**PLANNING PERMIT APPLICATION P/2021/6169 Subdivision
609 to 621 Burwood Highway, Knoxfield
Response to Request for Information**

We write on behalf of Development Victoria (the applicant) in relation to planning permit application P/2021/6169 (subdivision) at 609 to 621 Burwood Highway, Knoxfield. The purpose of this correspondence is to provide a response to the further information request issued by Knox City Council (Council) in relation to the abovementioned planning permit application. We note that the responses have been prepared by Development Victoria and its full project team.

PLAN OF PROPOSED RESERVES
CROWN ALLOTMENT 2258
PARISH OF SCORESBY
COUNTY OF MORNINGTON
609-621 BURWOOD HIGHWAY
KNOXFIELD

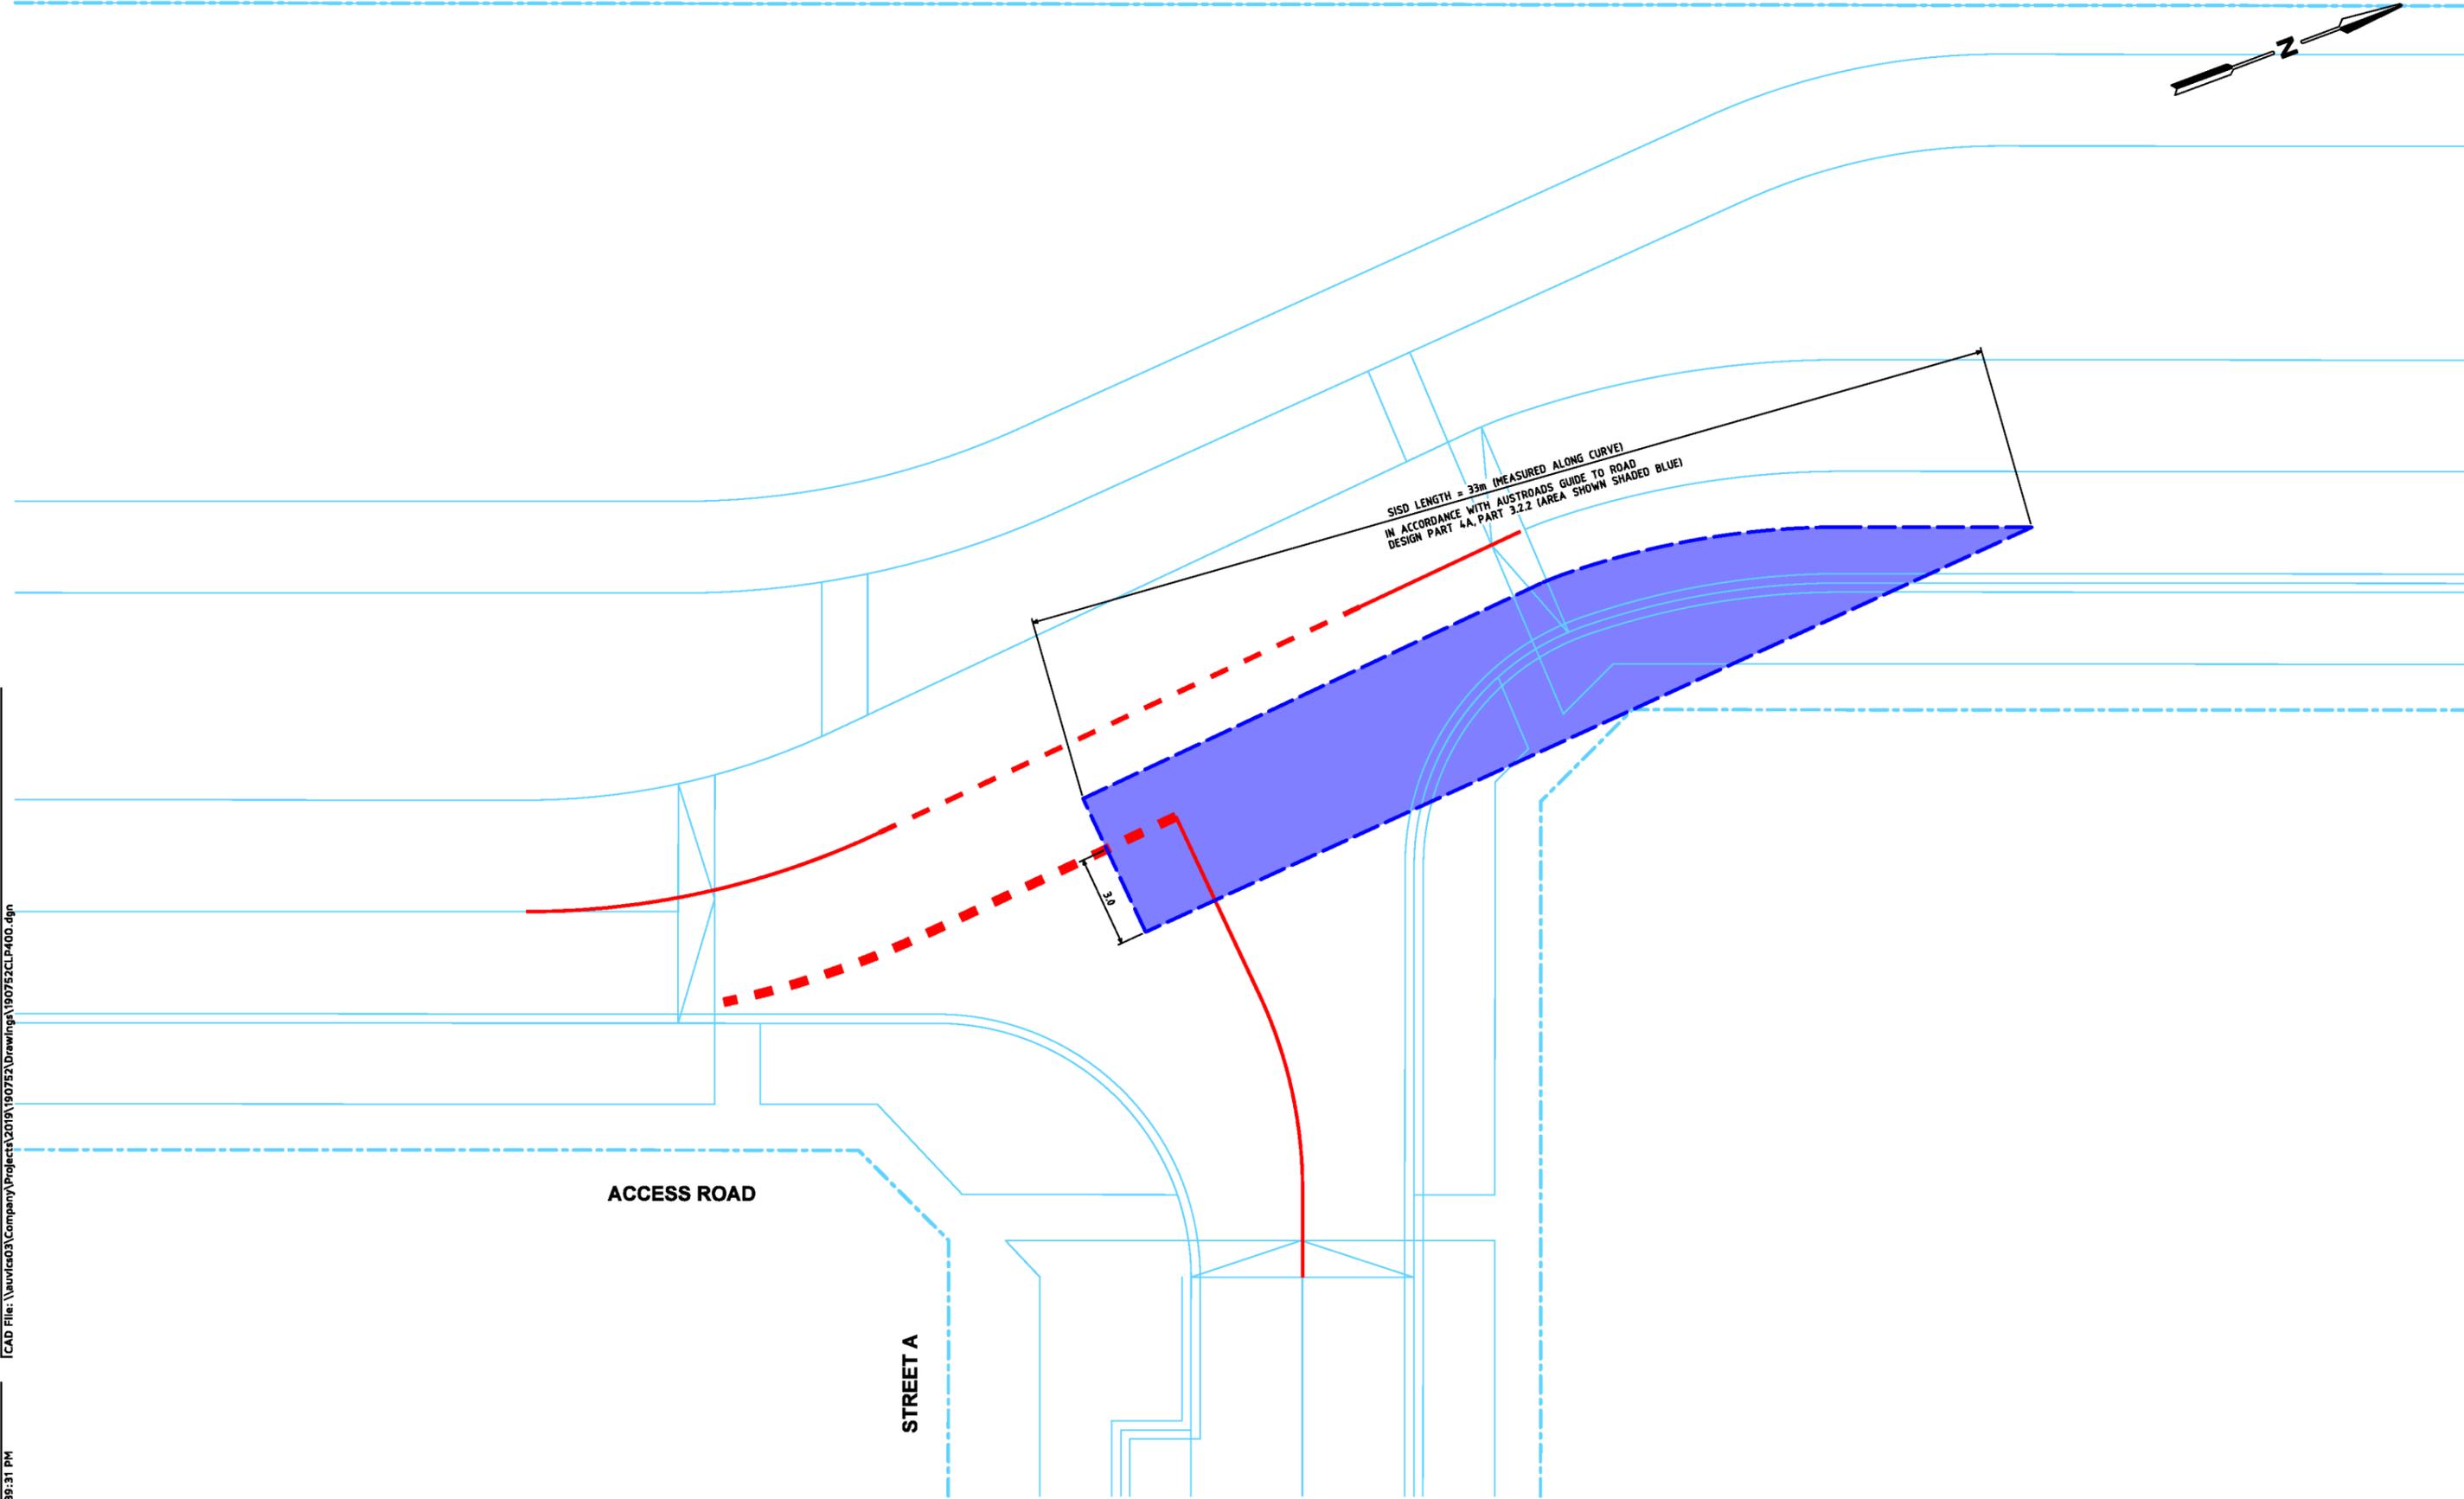
The proposed lots in stages 1 and 2 are all under 725 square metres and thus the public open space contribution to be applied is 8.5 per cent of the land. This provision will be met across the whole masterplan as set out in the tables below and in the attached public open space plan (refer appendix A public open space plan).

Stage	Unencumbered Public Open Space Reference (refer plan below)	Public Open Space Area (ha)	Percentage of total NDAh (15.8258 hectares)
1	1	0.1076	0.68
2	2	0.0975	0.62
3	3	0.1344	0.85
3	4	0.2843	1.80
3	5	0.1599	1.01
4	6	0.0272	0.17
4	7	0.0434	0.27
5	8	0.3038	1.92
5	9	0.0756	0.48
6	10	0.0823	0.52
6	11	0.2998	1.89
6	12	0.085	0.54
7	13	0.2065	1.30
7	14	0.084	0.53
Wetlands	15	0.291	1.84
Wetlands	16	0.5294	3.35
Total		2.8117 hectares	17.77 %

Drawing Title KNOXFIELD RESIDENTIAL DEVELOPMENT SITE VEHICLE ACCESS SWEPT PATH ANALYSIS	
Designed MOB		Meiway Ref 73 D1	
Scale 1:200 @ A3		Project Number 190752	Drawing Number SPA400
		Revision A

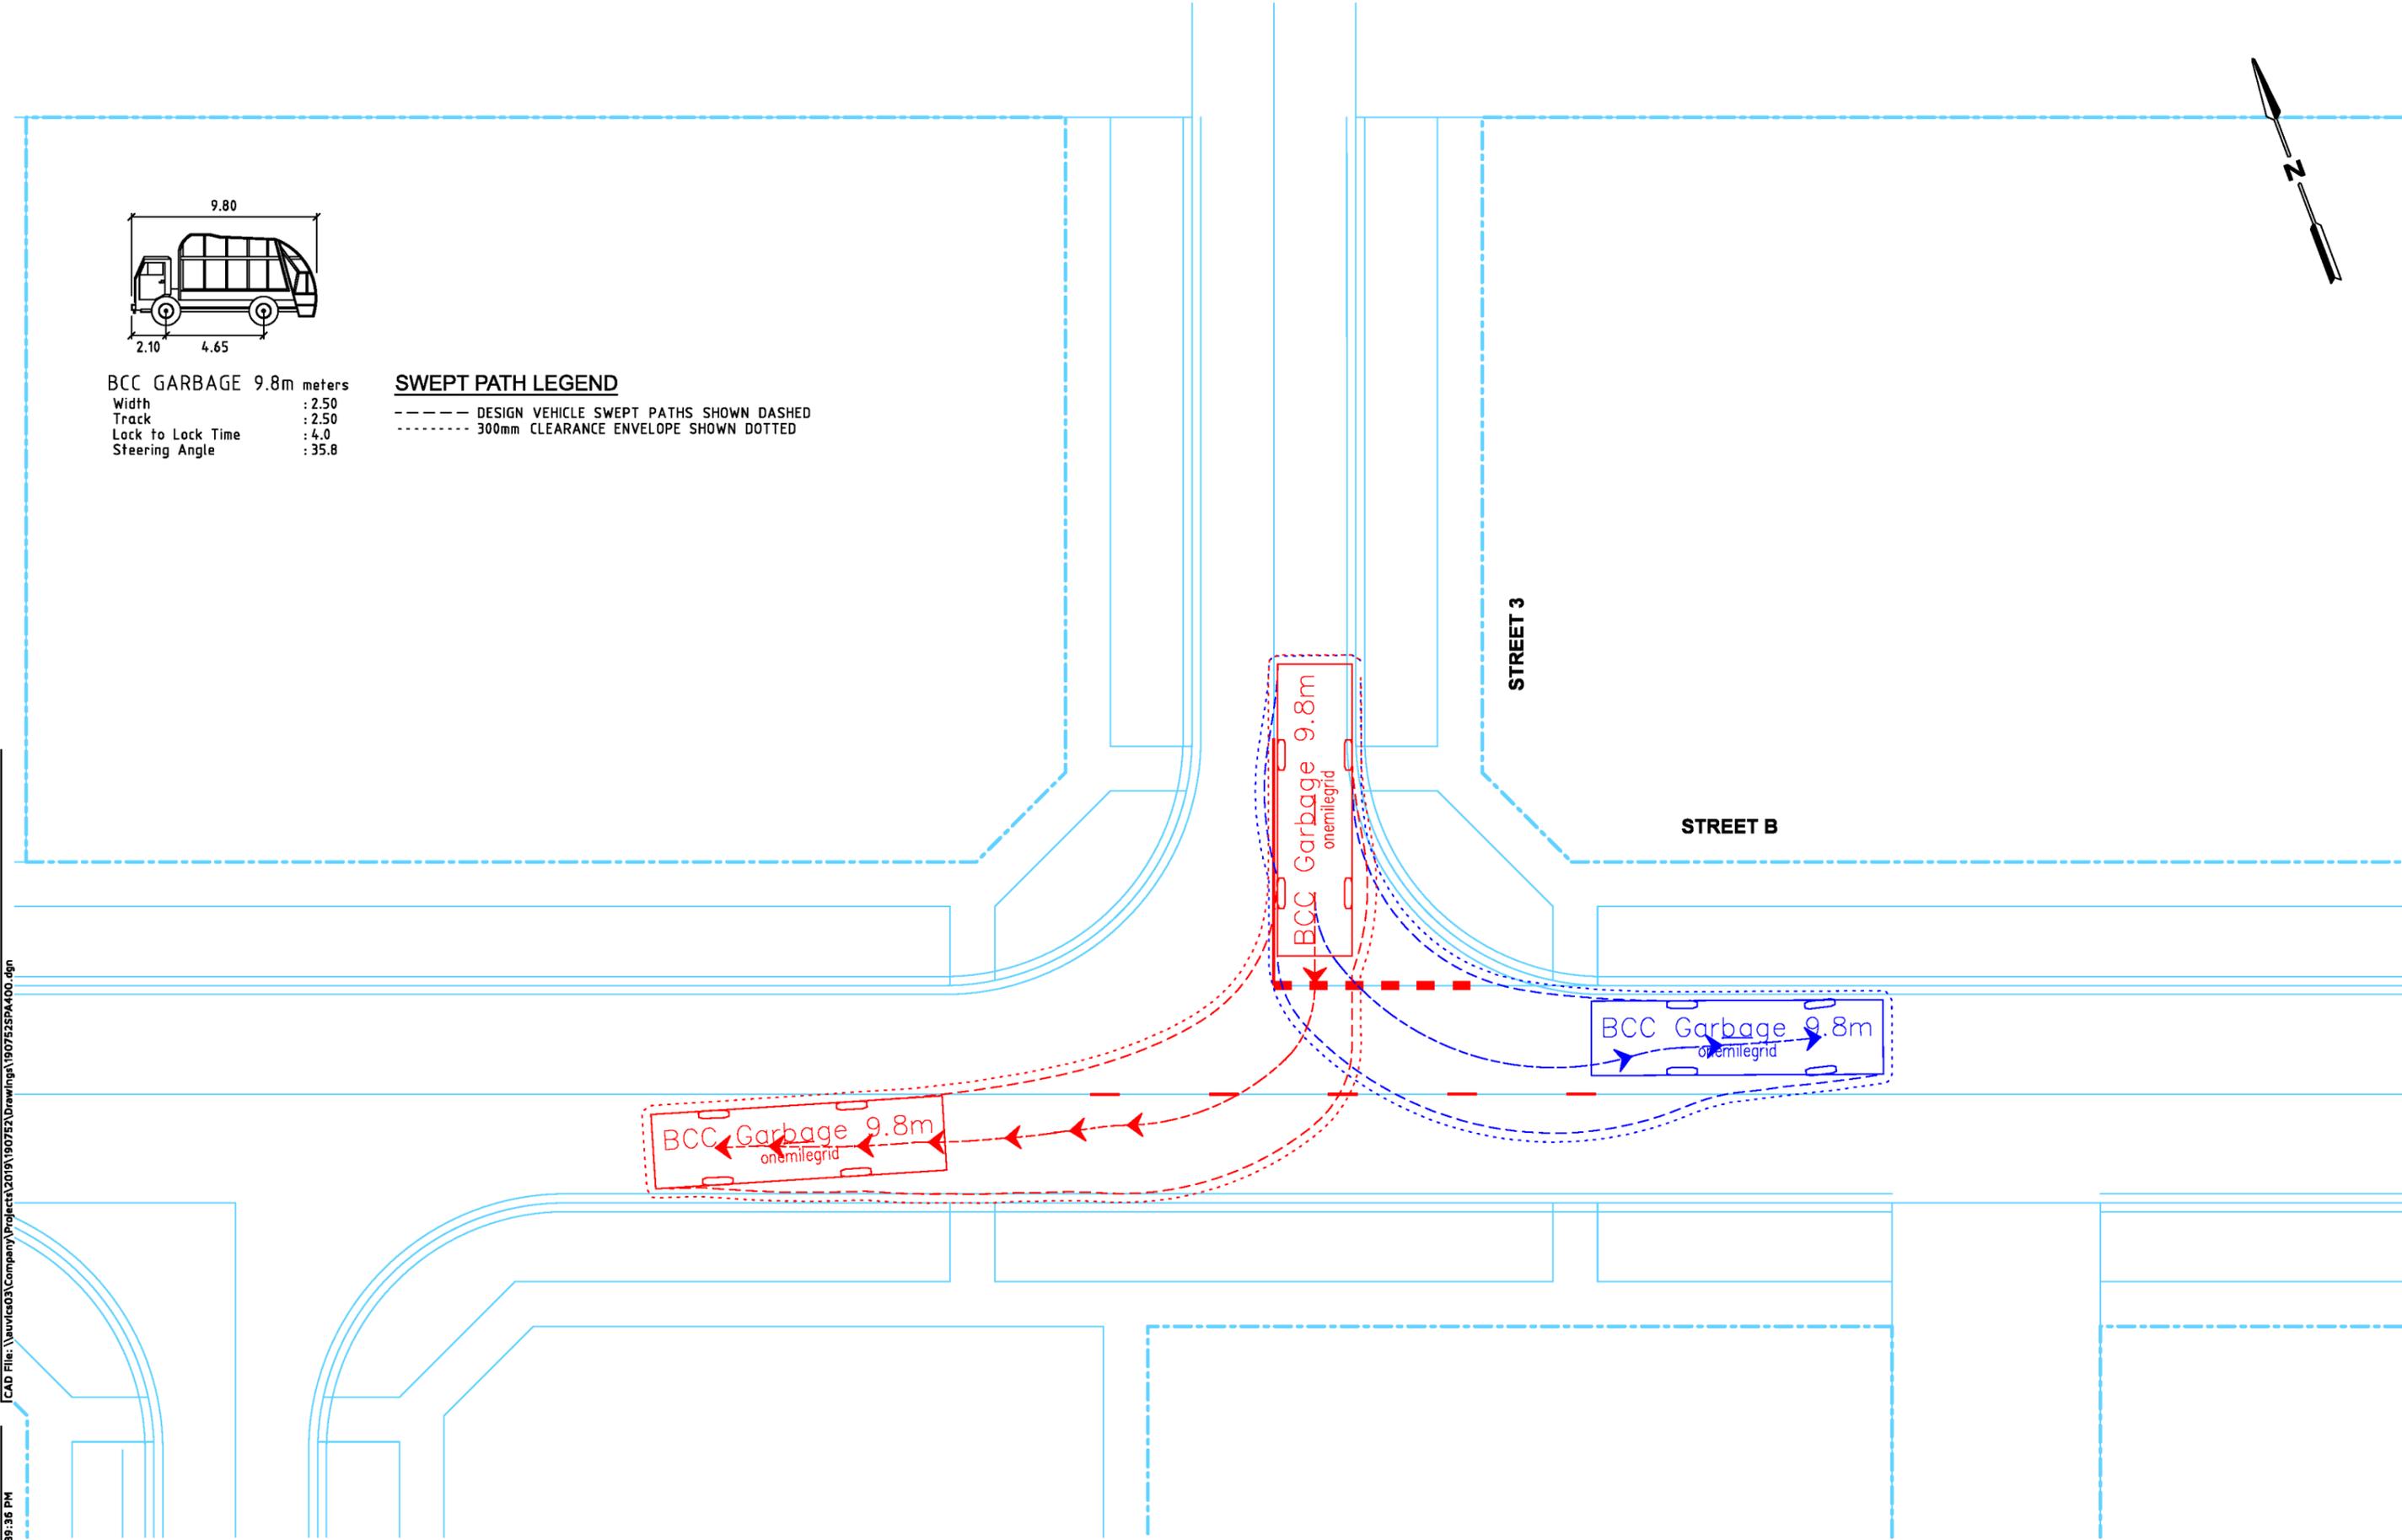
Swept paths for collection vehicles to be provided on Plan Drawings to demonstrate accessibility for collection vehicles including on-site manoeuvring, and confirmation entry and exit into and from the development can be in a forwards direction. If visitor car parking spaces are to be utilised for collection vehicle turning area(s), confirmation of how car parking spaces will be kept clear on collection days is required.

Similarly, the internal intersections are designed as standard residential T-intersections, with standard kerb radii, which are designed to allow for the required vehicles. Swept paths (refer appendix C typical swept paths) for a standard intersection design, show the movement of cars and service vehicles. It is acknowledged that should a passenger vehicle and a service vehicle arrive at the intersection simultaneously, the service vehicle may need to allow the passenger vehicle to leave the intersection before continuing, as is standard practice at the majority of residential intersections in the Municipality.
